### **On-Property Corrective Measures Implementation Construction Completion Report**

Subject:  
On-Property CMI Construction Documentation Report  
Koppers Inc. Superior, Wisconsin Facility  
WDNR BRRTs No: 0216000484  
WDNR Facility ID: 816009810

**On-Property Corrective Measures  
Implementation Construction  
Documentation Report**

Koppers Inc. Facility  
Superior, Wisconsin

**C200**

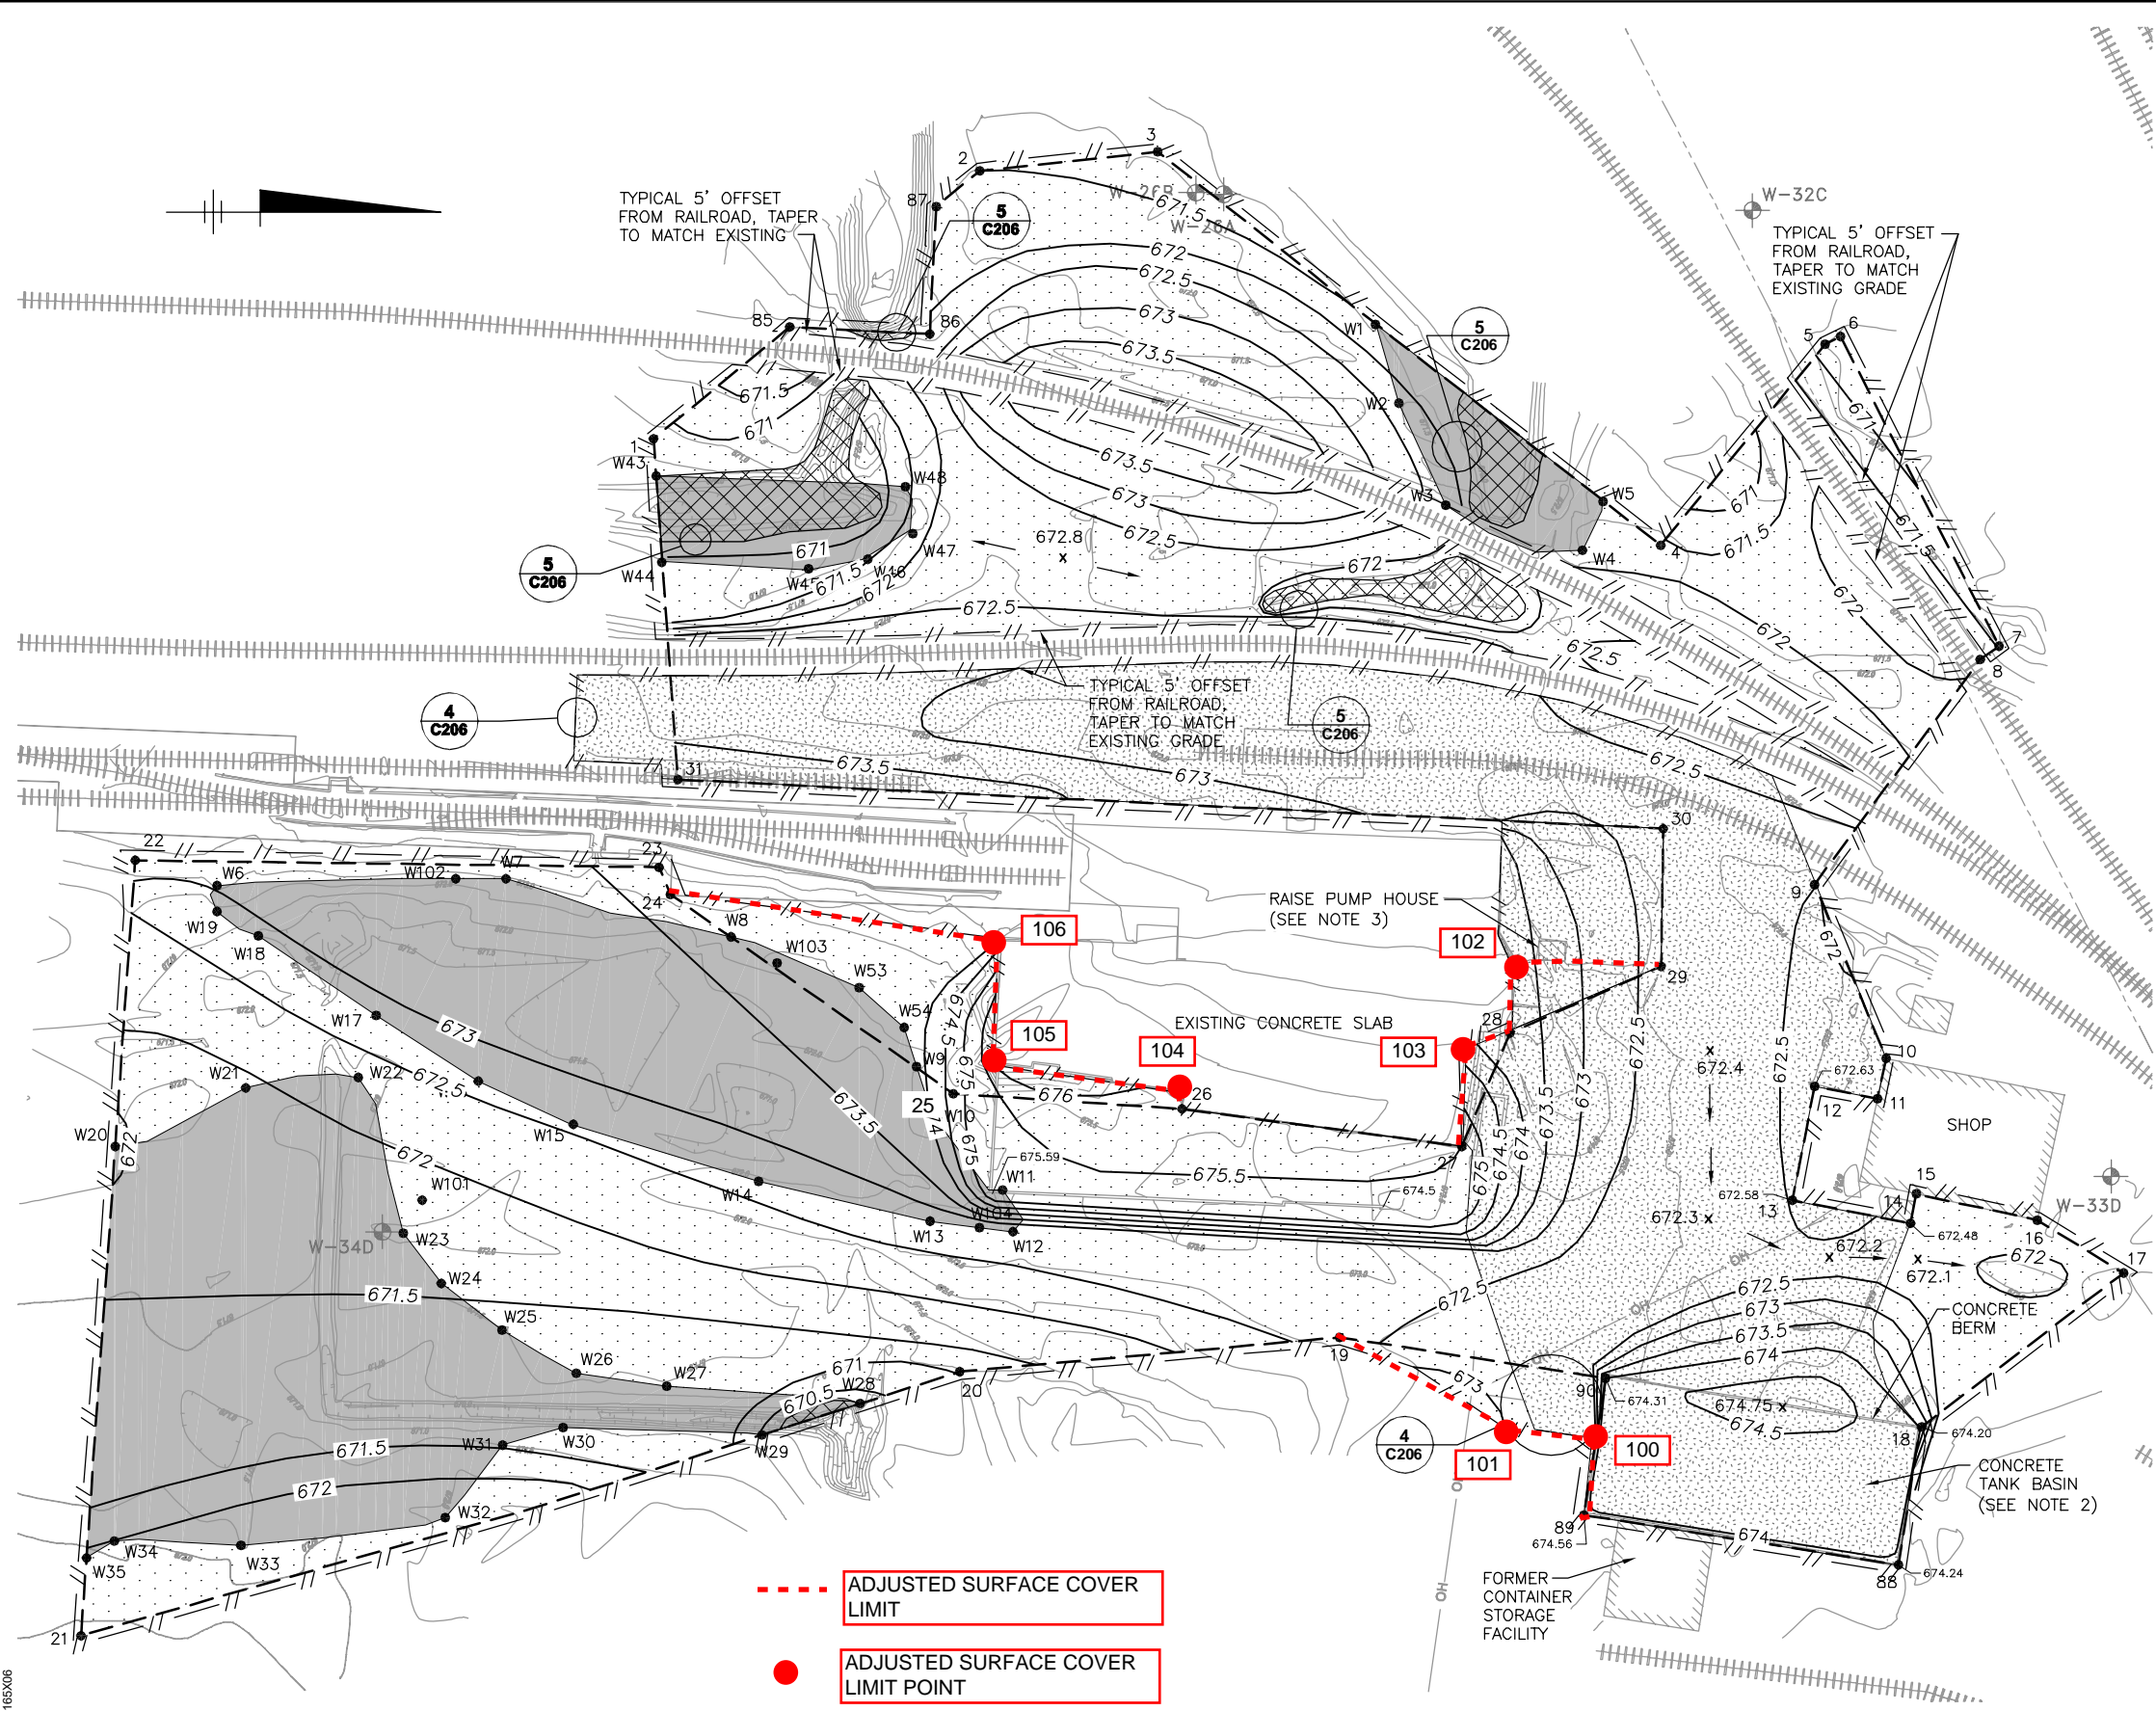
Attached Contract Drawing C200 depicts the final Surface Cover Limits for Area B..

As noted on attached Contract Drawing C200, existing Surface Cover Limits 25 and 90 are within the revised surface cover, and the revised surface cover resulted in new Surface Cover Limits 100 through 106.

**AREA F1 & F2**

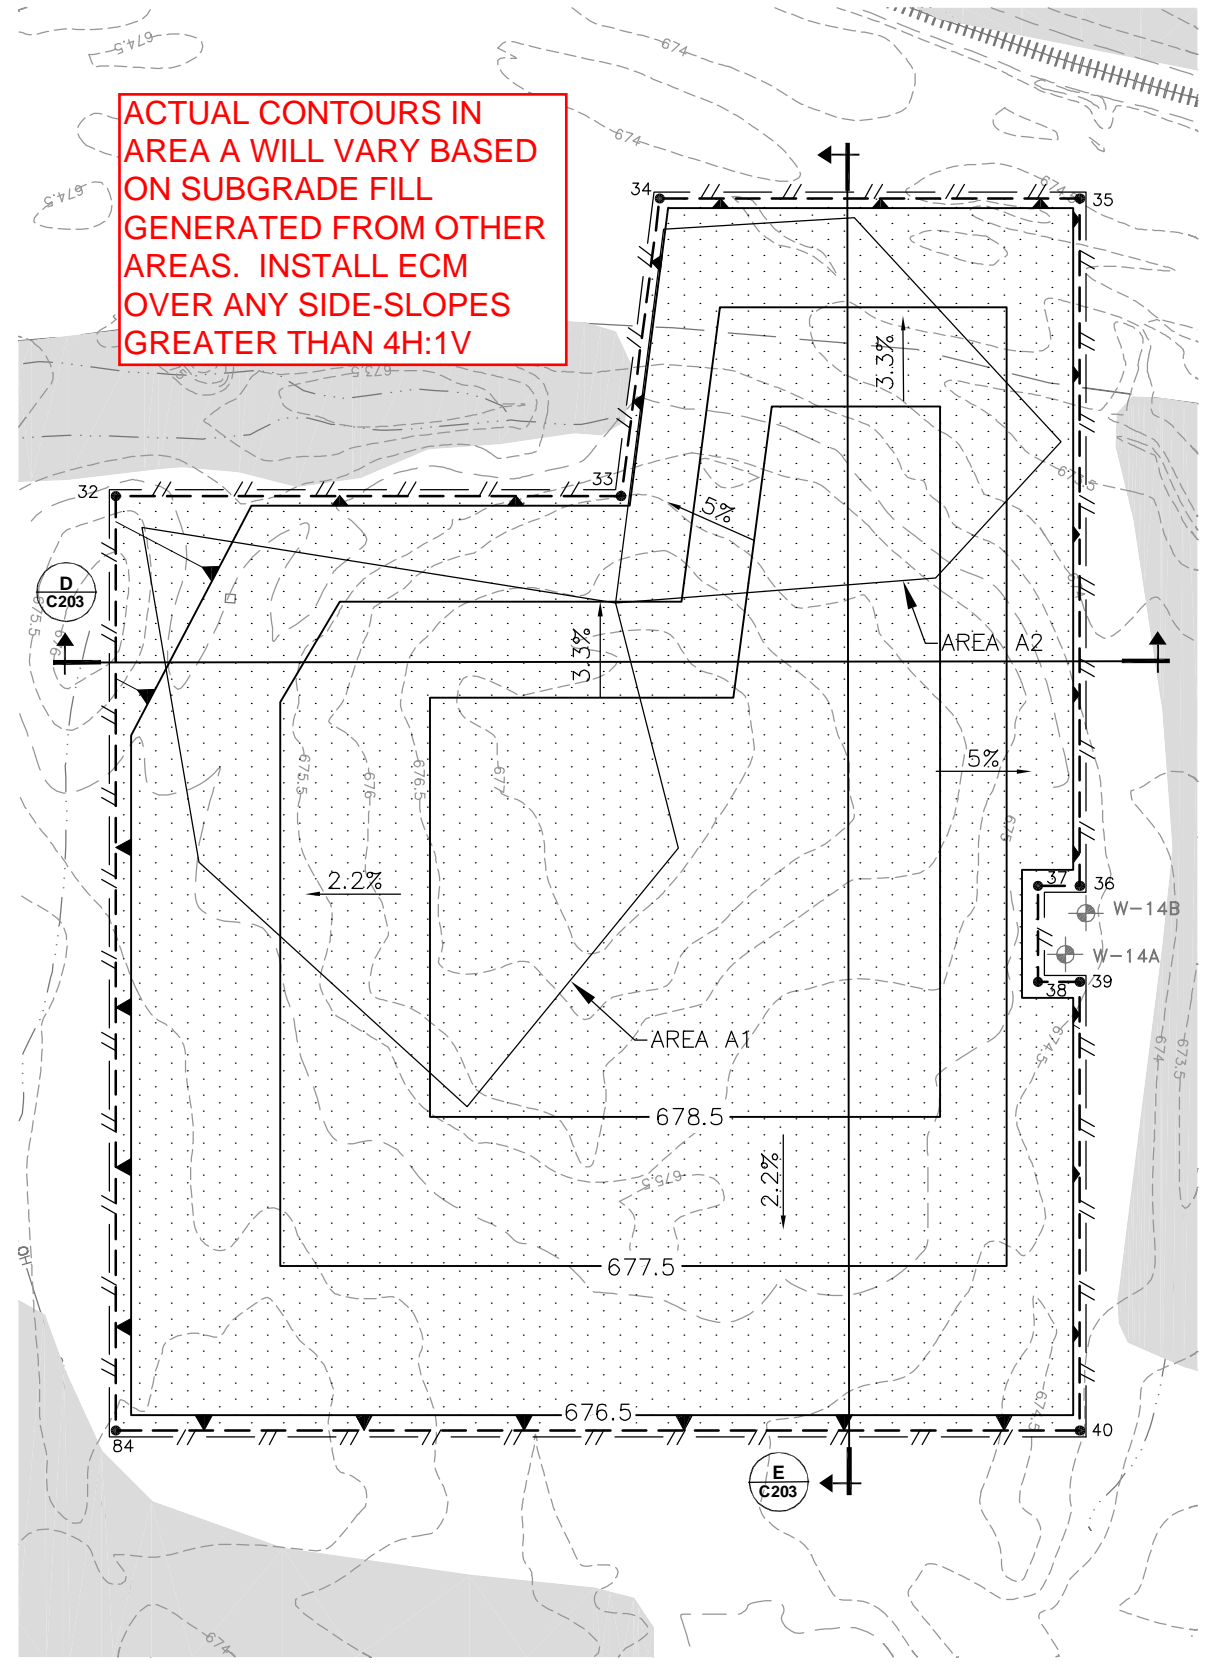
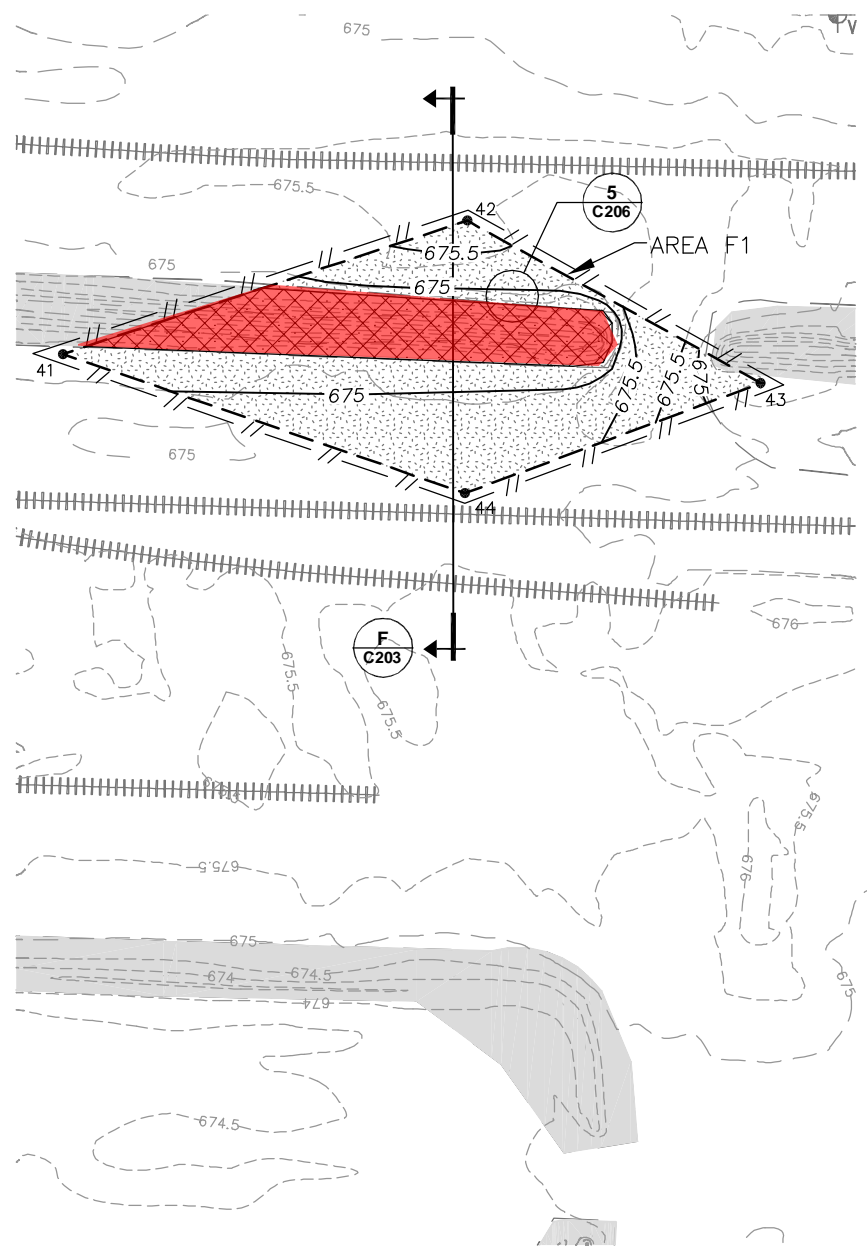
- b. Following re-seeding, install ECM in the vegetated wetland ditch as shown in attached Contract Drawing C202 in accordance the manufacturer's installation procedures (Attachment B).

**ACTUAL CONTOURS IN AREA A WILL VARY BASED ON SUBGRADE FILL GENERATED FROM OTHER AREAS. INSTALL ECM OVER ANY SIDE-SLOPES GREATER THAN 4H:1V**
